**Work Plan Addendum
Additional Sampling for
CC RVAAP-79 DLA Ore Storage Sites Remedial Investigation,
Ore Storage Pond Sub-Area,
Ravenna Army Ammunition Plant Restoration Program,
Portage and Trumbull Counties, Ohio**

**Subject: Review of Final Work Plan Addendum: Additional Sampling for CC RVAAP-79
DLA Ore Storage Sites Remedial Investigation, Ore Storage Pond Sub-Area**

Subject: Responses to Comments (dated February 26, 2021) on the *Draft Work Plan Addendum: Additional Sampling for CC RVAAP-79 DLA Ore Storage Sites Remedial Investigation, Ore Storage Pond Sub-Area* dated January 14, 2021, for the Ravenna Army Ammunition Plant (RVAAP) Restoration Program, Portage and Trumbull Counties, Ohio. Ohio EPA ID# 267-000859-258

**Draft Work Plan Addendum:
Additional Sampling for CC RVAAP-79 DLA Ore Storage Sites,
Ore Storage Pond Sub-Area
Ravenna Army Ammunition Plant (RVAAP) Restoration Program, January 14, 2021.
Ohio EPA ID# 267-000859-258**

**Figure 4-1
Proposed Sediment Sampling Locations
at Ore Storage Pond
CC RVAAP-79 DLA Ore Storage Sites**

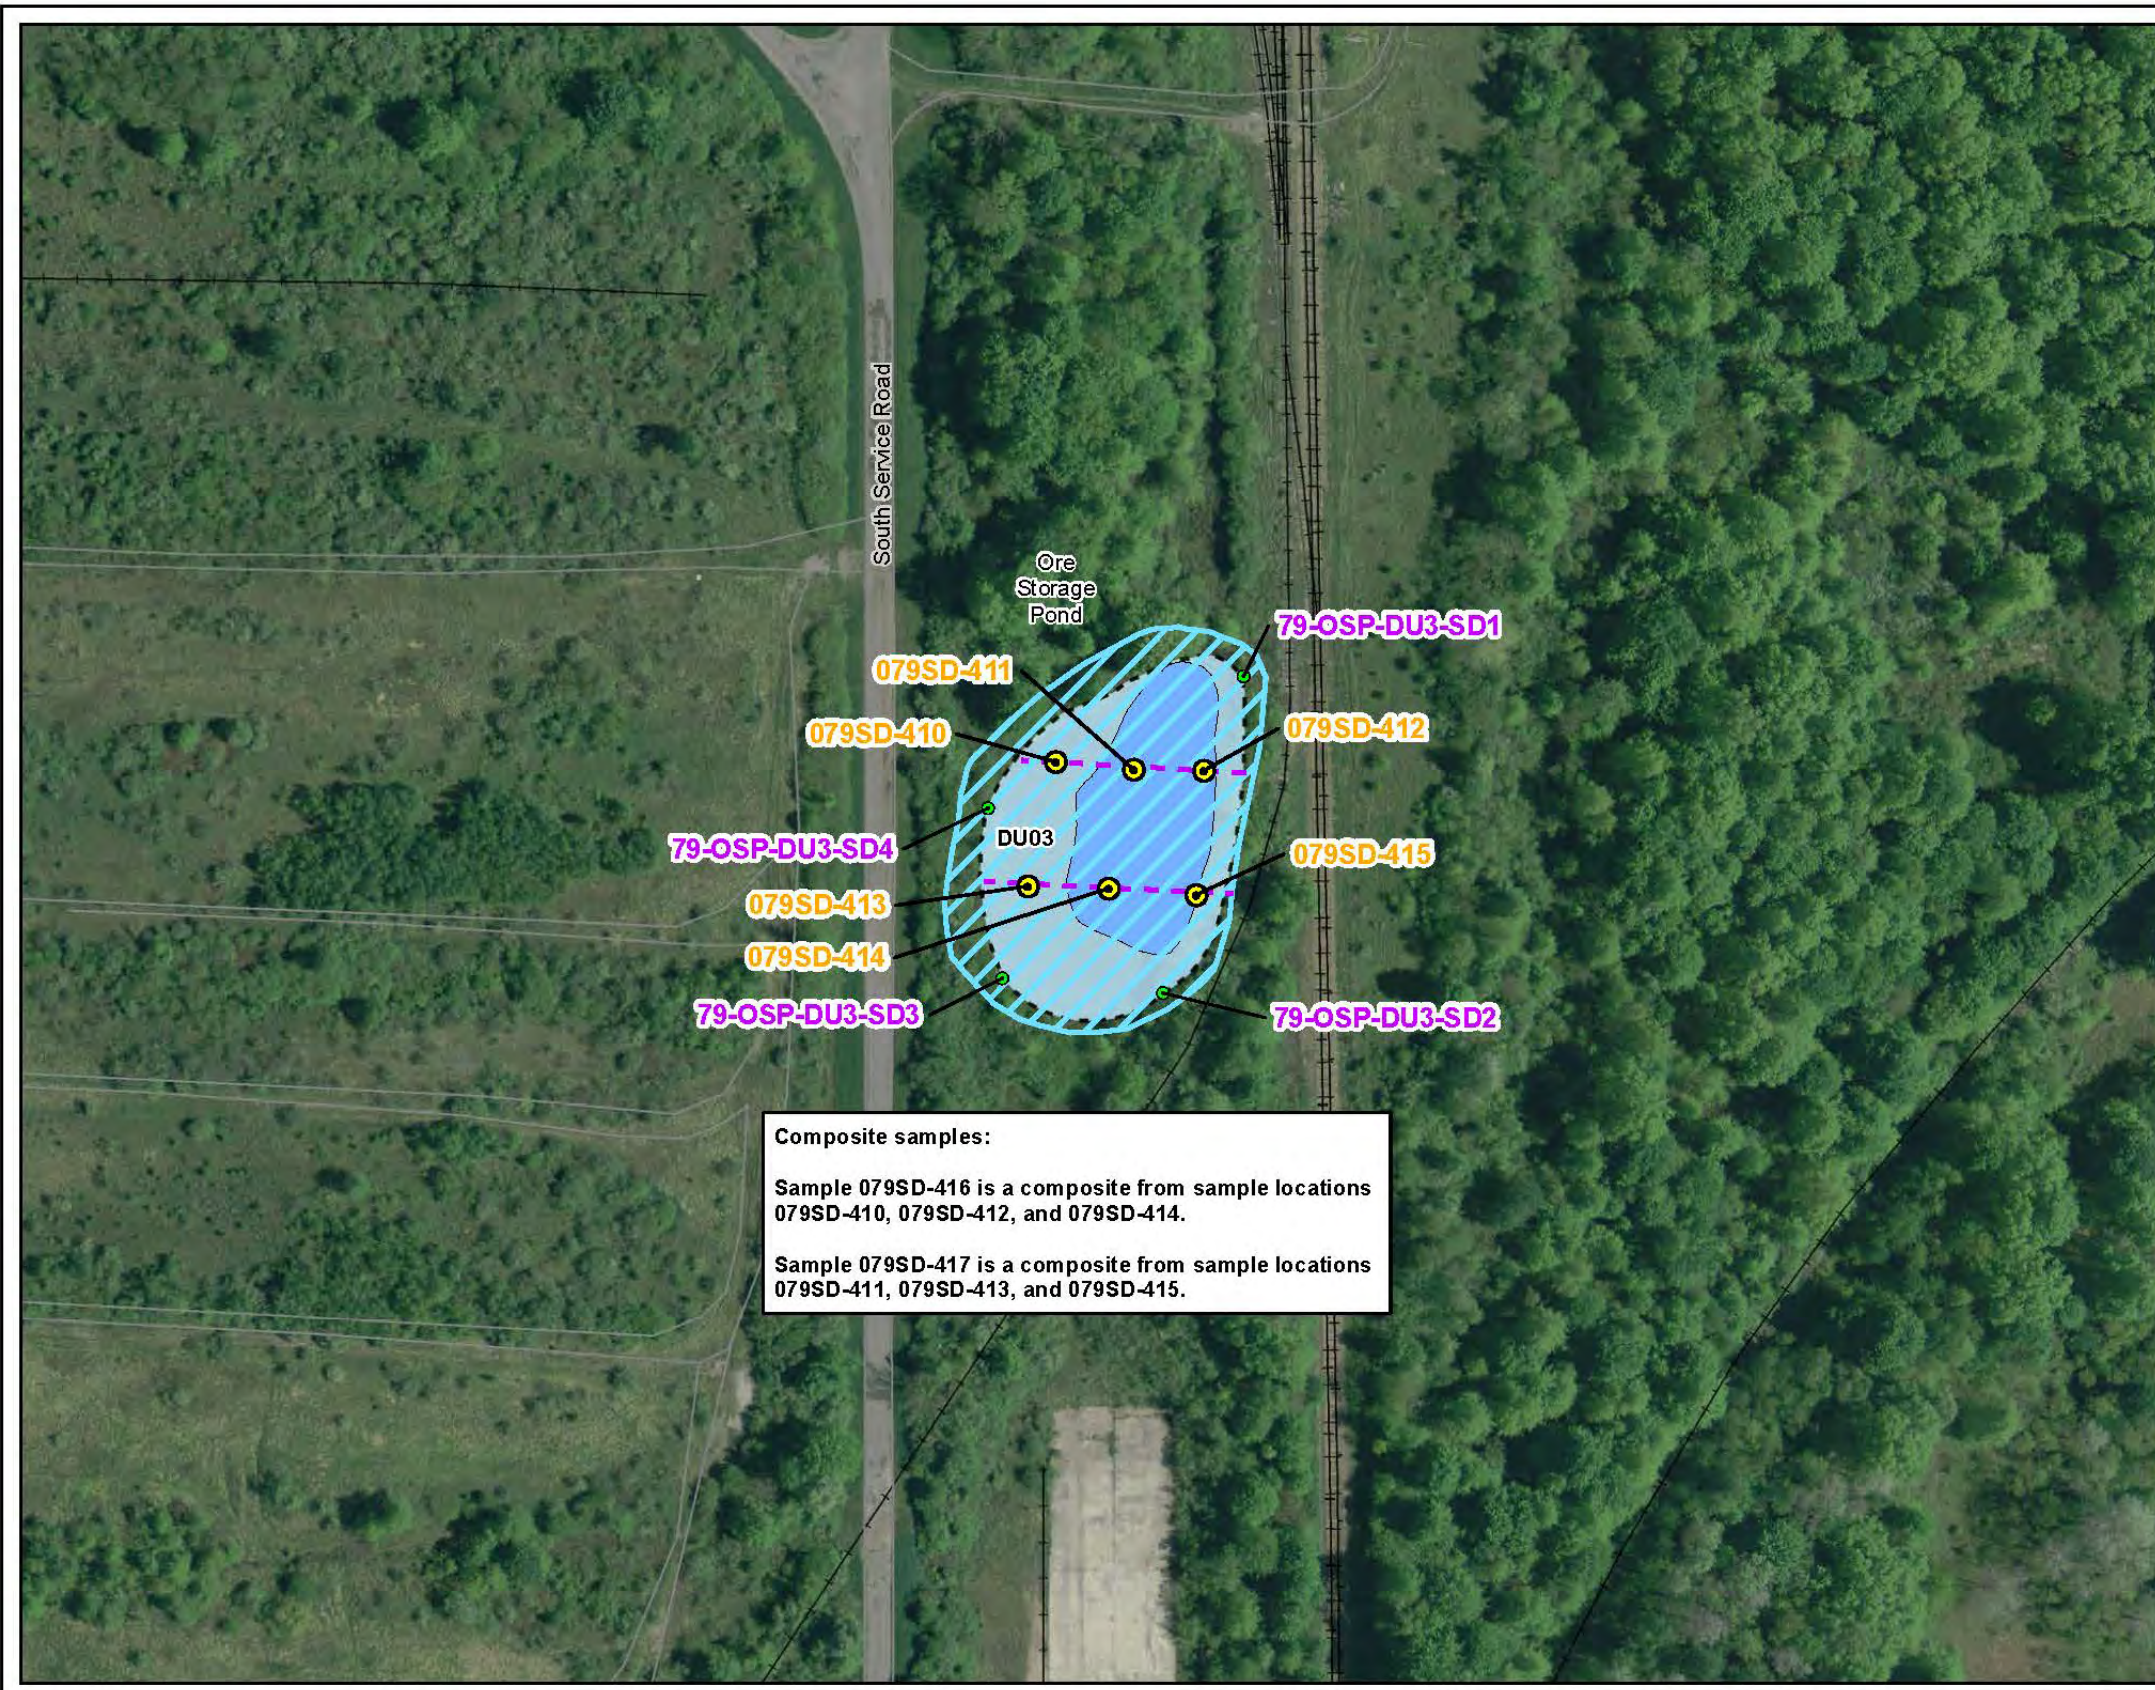
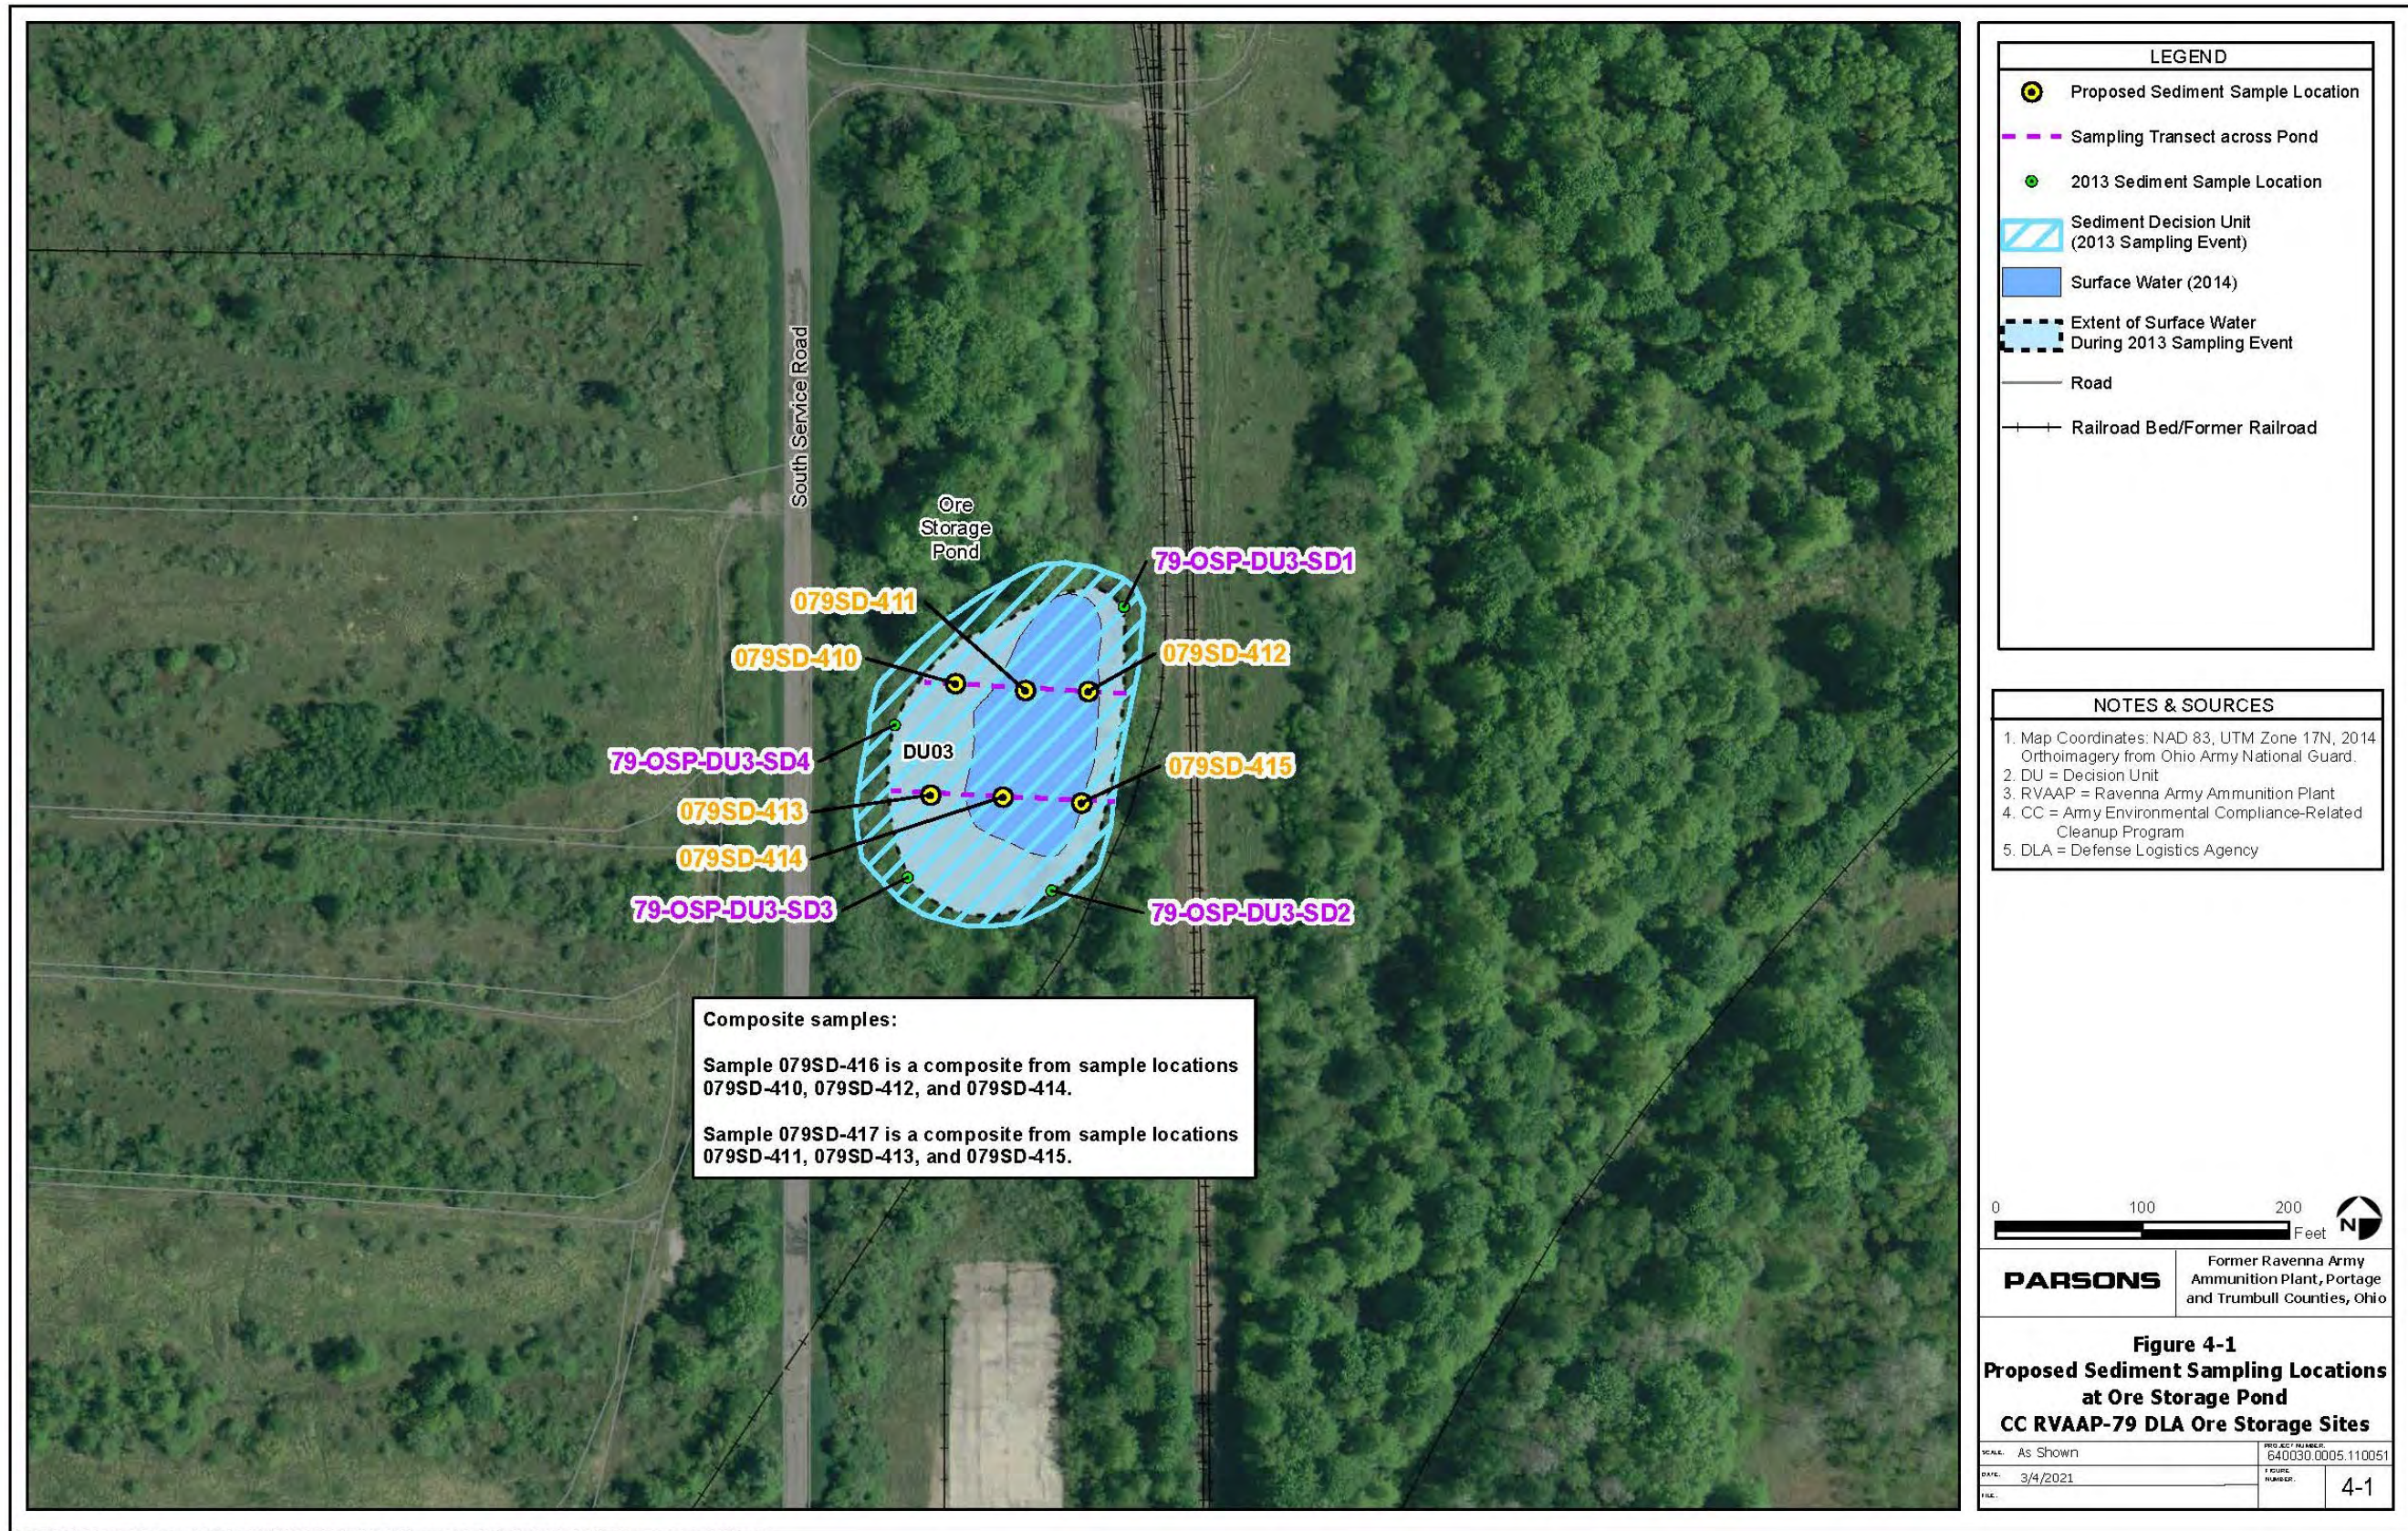
2.) Section 4.1: Sediment Sampling: The current WPA is suggesting a single transect that runs through the area of the pond with largest area of open water. Ohio EPA recommends two transects running perpendicular to and instead of the current line, one crossing approximately between samples 411 and 412, and one approximately between 413 and 414 (Figure 4-1 draft WPA). A total of six samples as proposed in the draft WPA is sufficient, with three from each suggested transect. Wetland sediment/soil should also be included but only within the historical boundary of the ore storage pond. The proposed single transect in the draft WPA avoids the sediment sample with the maximum concentration of arsenic. The two-transect approach should provide representative sediment samples for the bioassay work.

Response: Agree. Please see attached revised Figure 4-1 for new sample transects and locations.
